### Addendum # 1

**Bid Opportunity: 25-7736-RFT**

# Waterloo-Oxford District Secondary School ACE Classroom & Science Classroom Renovations

Closing Date: Thursday, April 17, 2025 2:00 PM

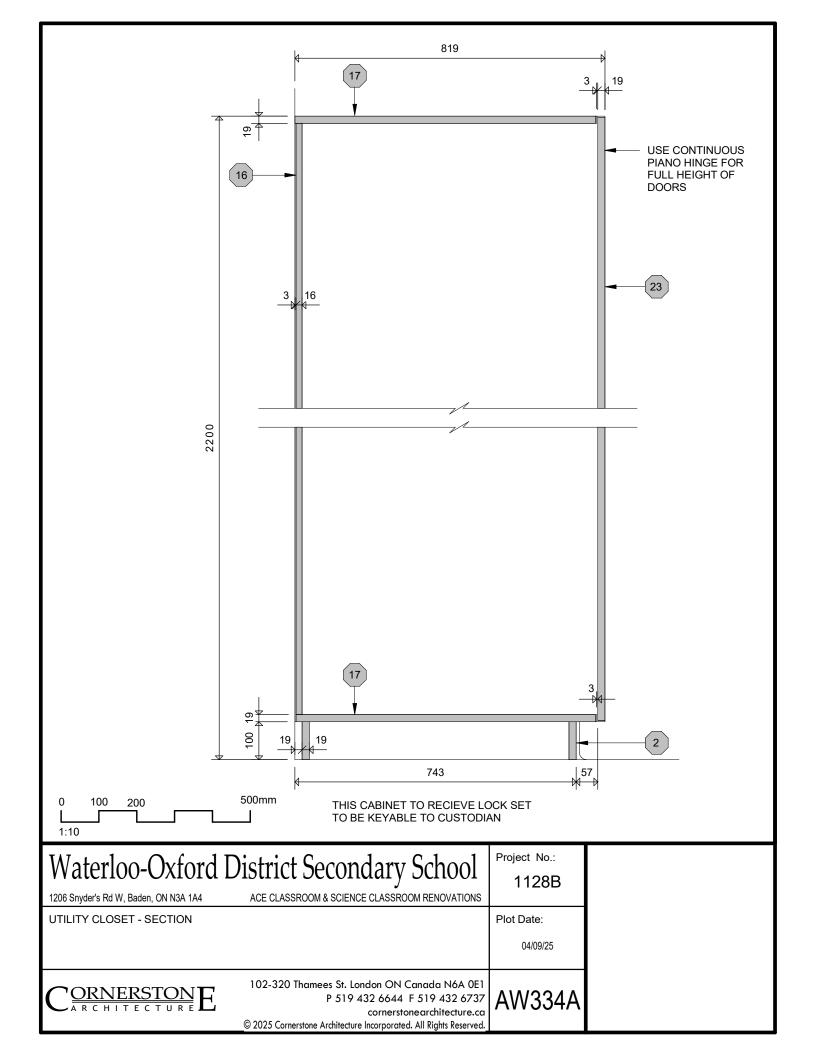
- .2 ADD Woodwork Details AW333A and AW334A, attached.
- .2 Section 10 90 00 Miscellaneous Specialties
  - .1 ADD Article 2.1.3 as follows:
    - .3 Double-sided Fume Hood: Provide Sigma Systems, twosided fume hoods #7221002 by Mott Lab Inc., where indicated on Drawings and as follows:

Drawings S2.1

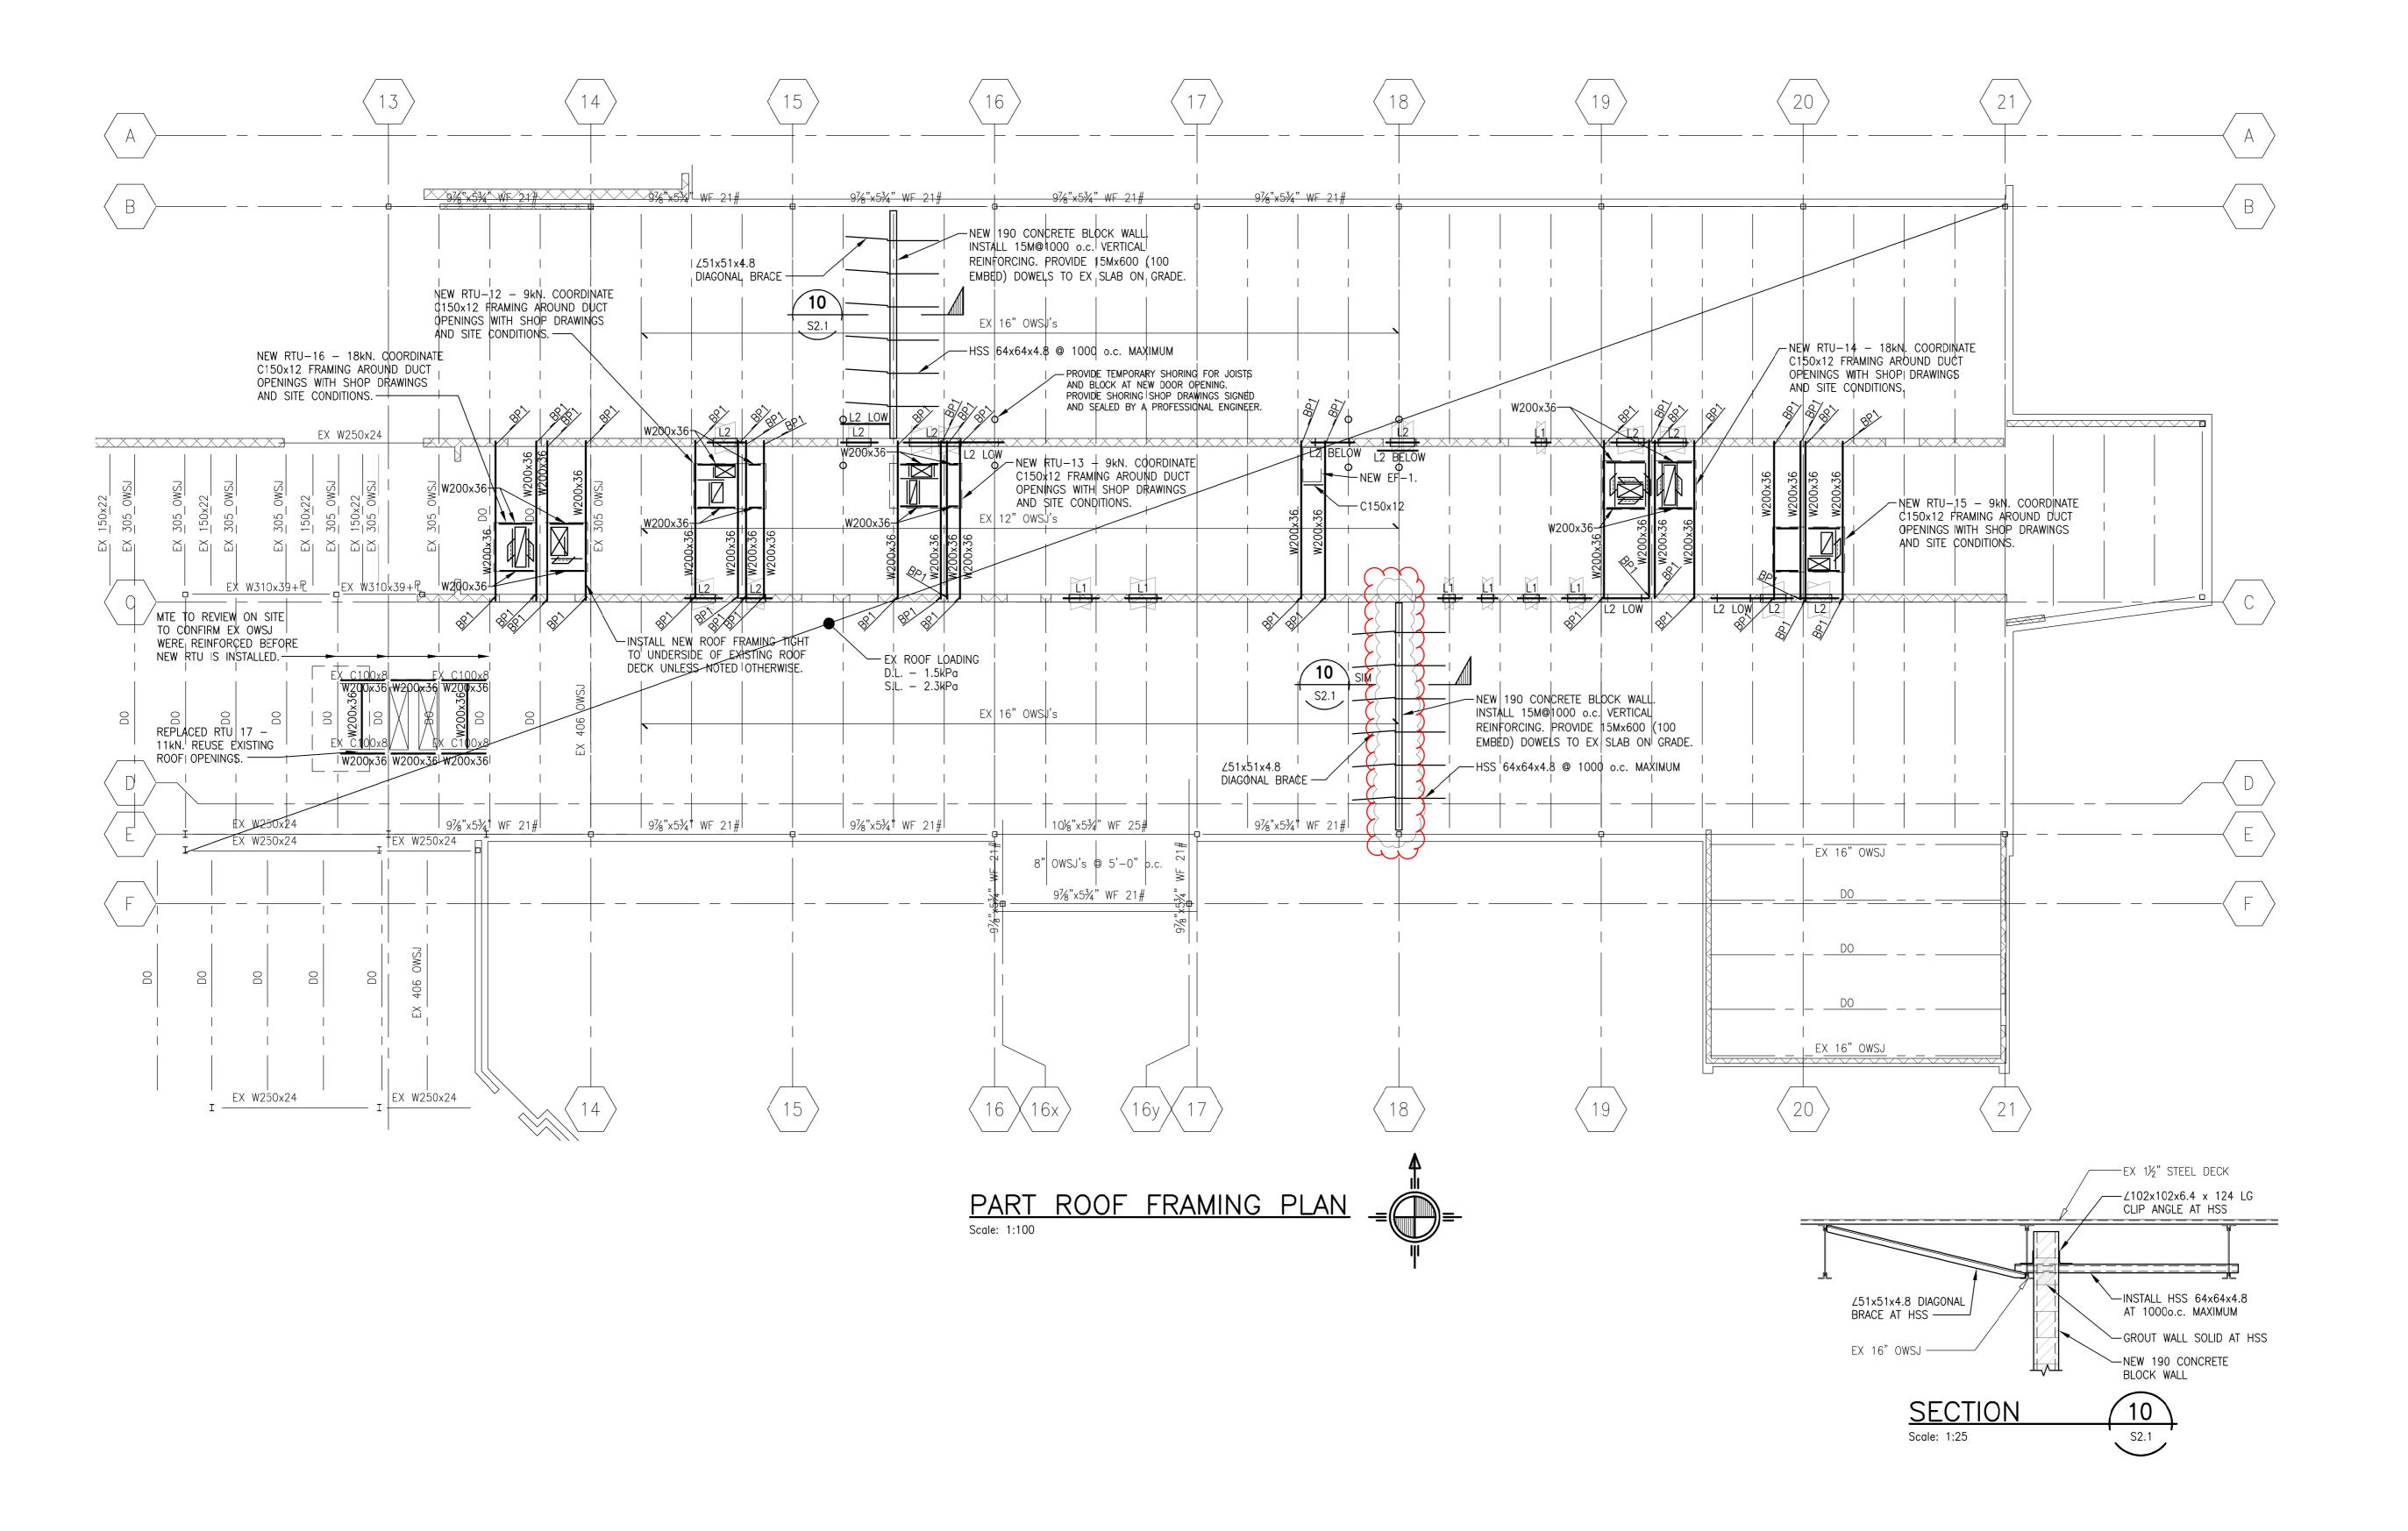
AMMENDMENT NO.1 DRAWING S2.1

**a.** Relocate 190 concrete block wall and steel near grid line 18 between C to E to be located on grid line 18.

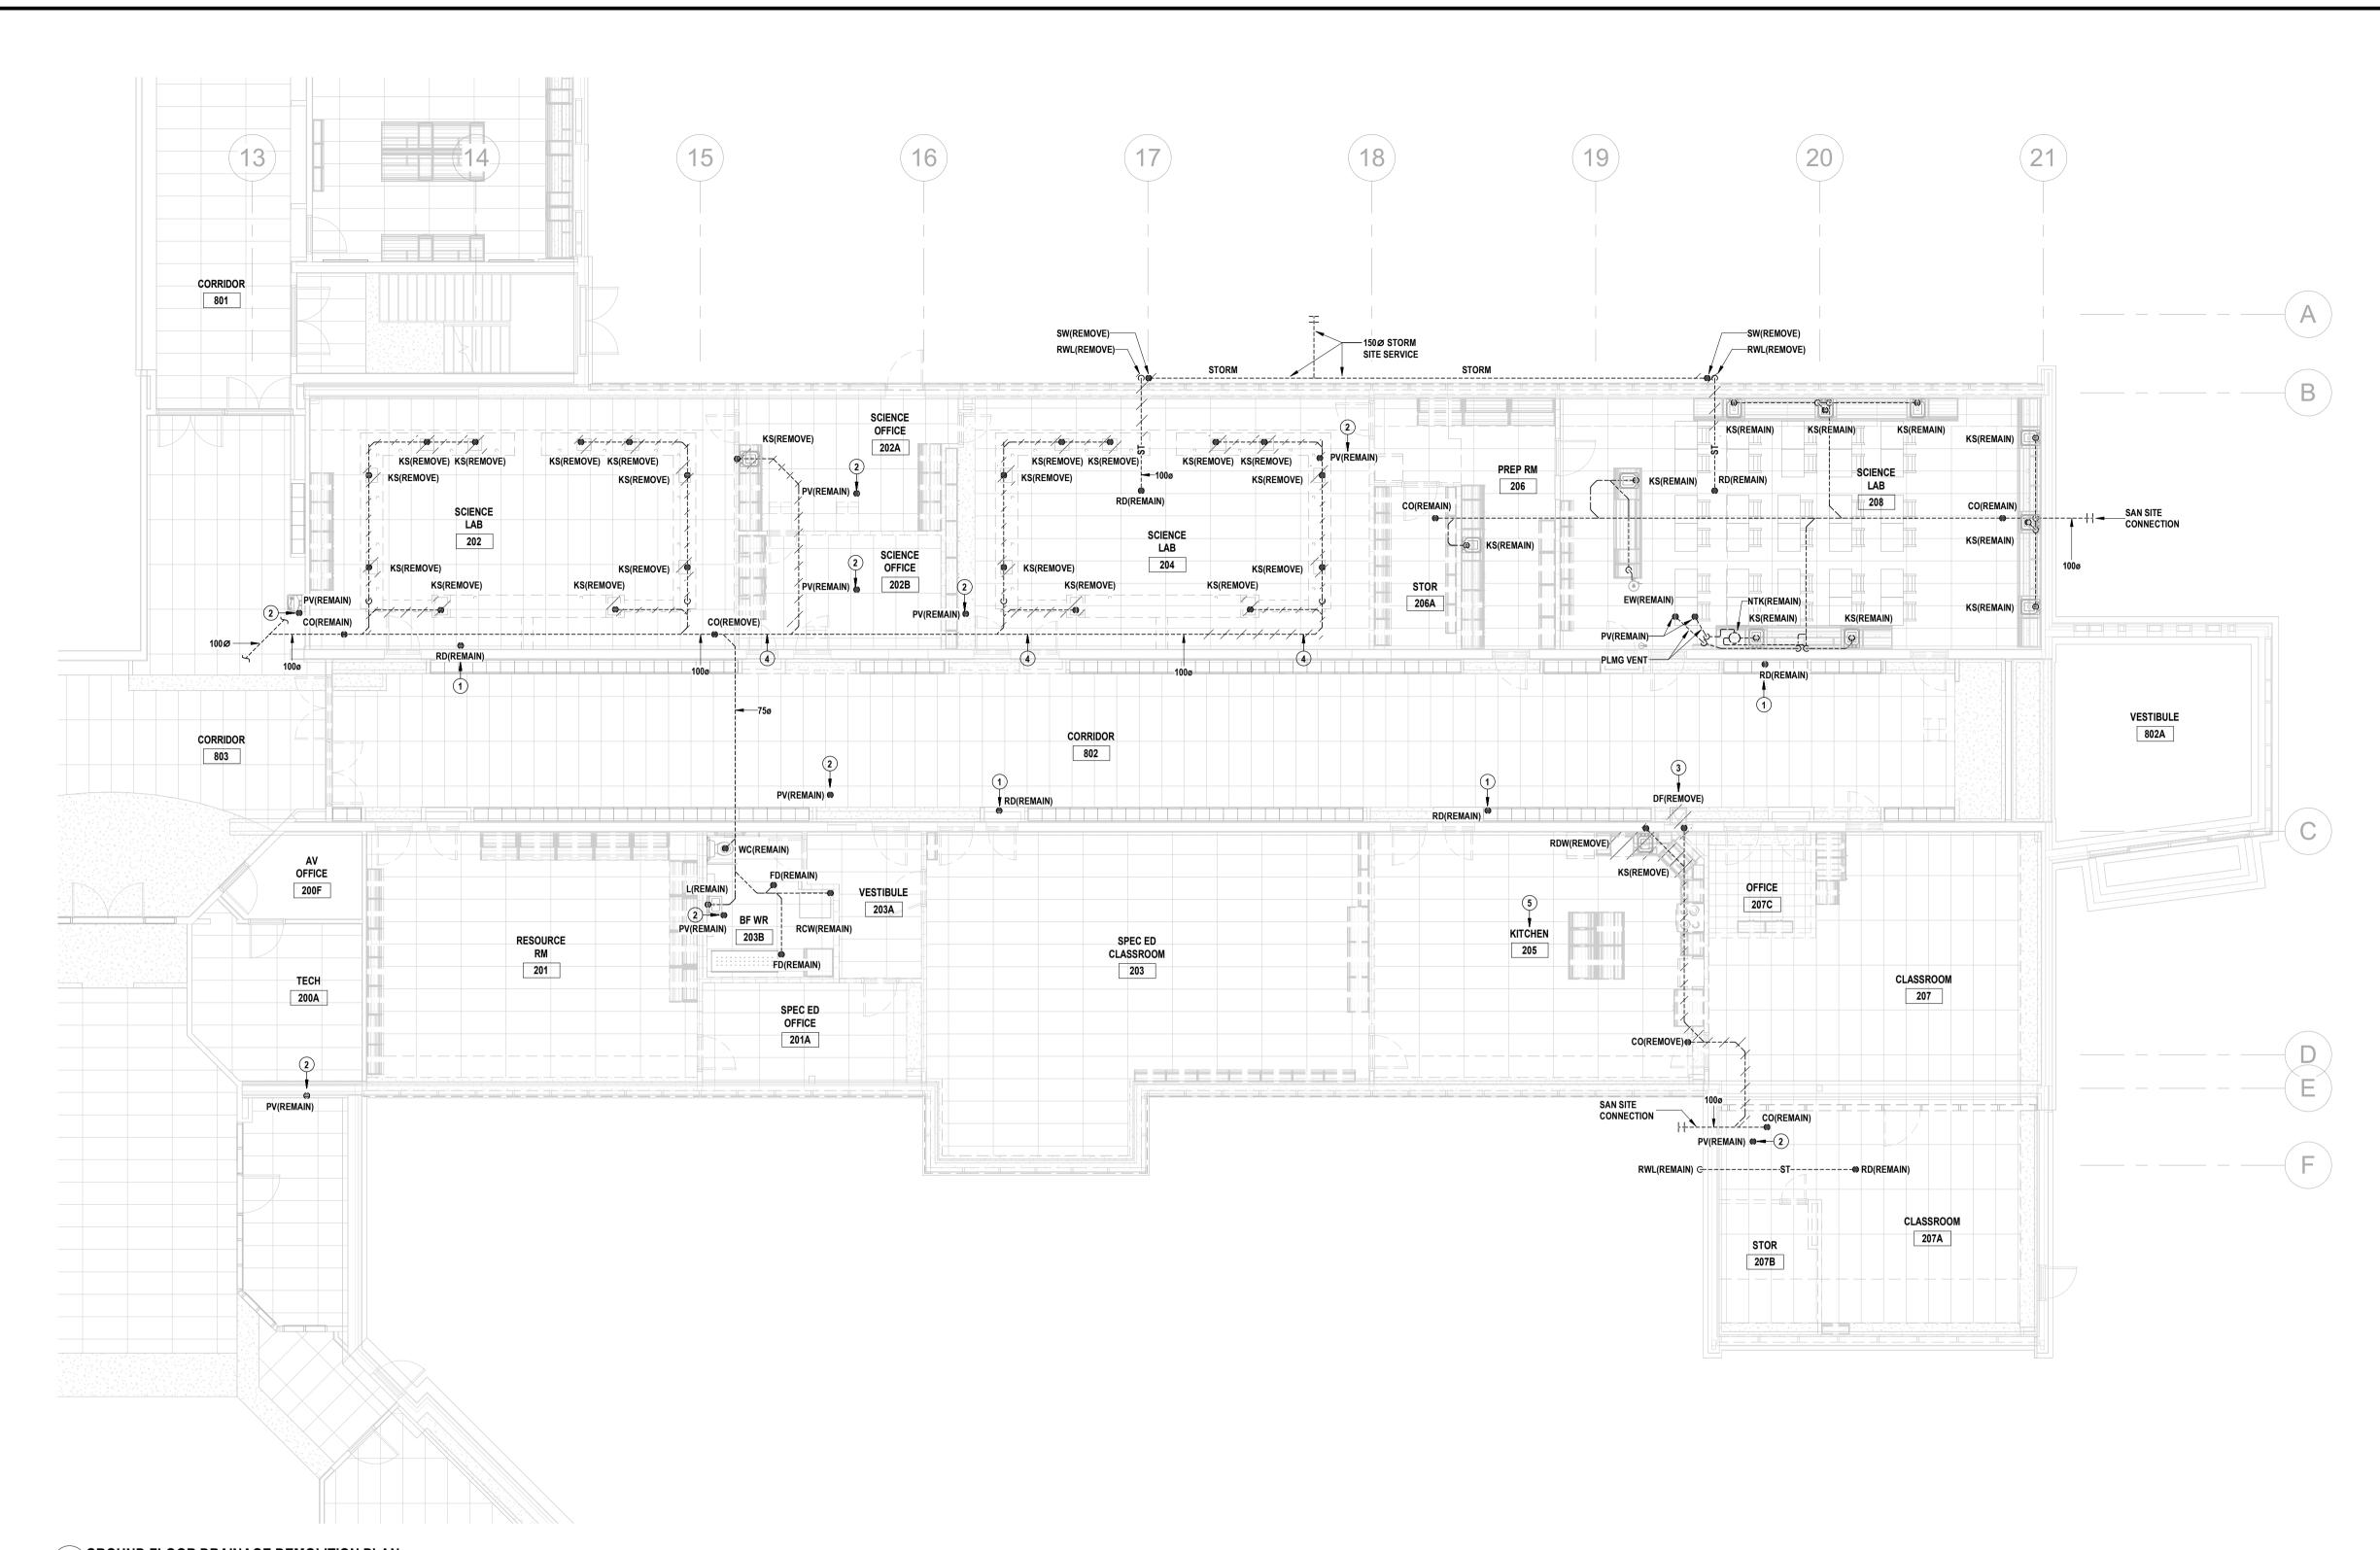
- c. In 203A Vestibule, provide mechanical power supply on corridor wall above ceiling.
- 7. Refer to drawing M3.5.
  - a. Relocate two existing plumbing vent roof terminations around HVAC-13 such that they are greater than 3m from nearest mechanical air intake.

- b. Relocate two existing plumbing vent roof terminations around HVAC-14 such that they are greater than 3m from nearest mechanical air intake.
  - c. Provide note 10 to HVAC-17 to read:

- "Obtain 2001 Library addition drawings from Owner for room number and airflow references. Re-balance airflows to match 2001 drawings at the following supply air outlets in the indicated spaces associated with this rooftop unit:

- 117A office: 1x multi-cone-type diffuser.
    - 120 office: 1x multi-cone-type diffuser.
    - 122/123/127 individual study area: 6x multi-cone-type diffusers.

- 124 conference: 3x multi-cone-type diffusers.
    - 125/126/128 main library space: 11x slot-type diffusers.

Re-balance airflows to match 2001 drawings at the following return air inlets in the indicated spaces associated with this rooftop unit:

- 117A office: 1x eggcrate-type grille.
- 120 office: 1x eggcrate-type grille.
- 122/123/127 individual study area: 2x eggcrate-type grilles.
- 124 conference: 3x eggcrate-type grilles.

Re-balance supply airflows at 4x VVT zone dampers associated with rooftop unit to match 2001 drawings."
